UNIVERSITY SURVEY & ADA EVALUATION

Priority 1 - Parking

Bldg Example 100

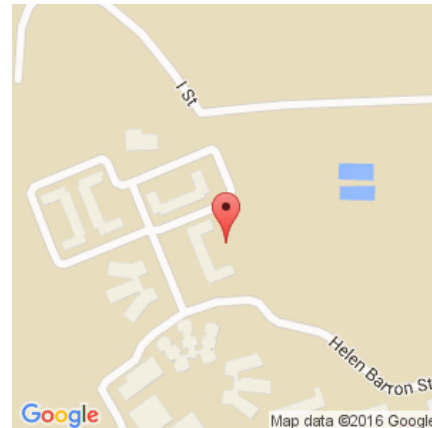
Comments: Findings - There are 4 accessible spaces. There are 3 van and 1 car accessible space.

Recommendations - There could be more access space.

Comments: Findings - The access space is 9 feet 2 inches and the access aisle is 60 inches or 5 feet.

Comments: Findings - The access space is 11 feet and the access aisle is 5 feet.

Value: The bottom of the sign is below 60 inches.

Comments: Findings - The signs range from 57 inches to 60 inches.

Value: The signs must be raised and I also recommend repainting the accessible parking spots.

Bldg Example 12

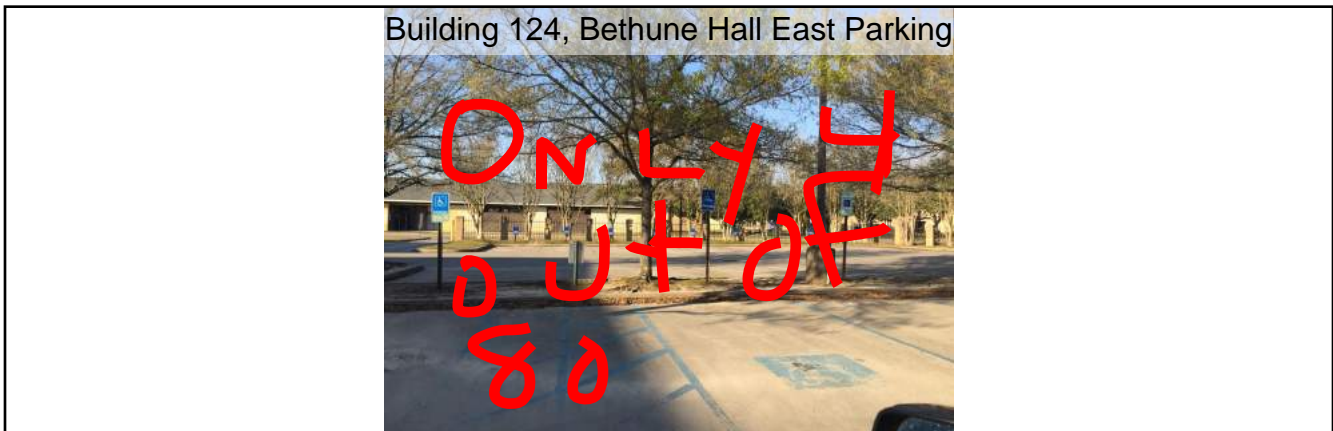
Value: No

Comments: There are only four out of 80 parking spaces that are for the handicapped.

Value: Yes, but they could be updated to reflect stronger color

Value: No

Value: More handicapped parking spaces are needed. Accessible lanes to the building should be provided. Access ramp to the building needs to be better marked, and it should include visual ridges feel ridges for the visually impaired
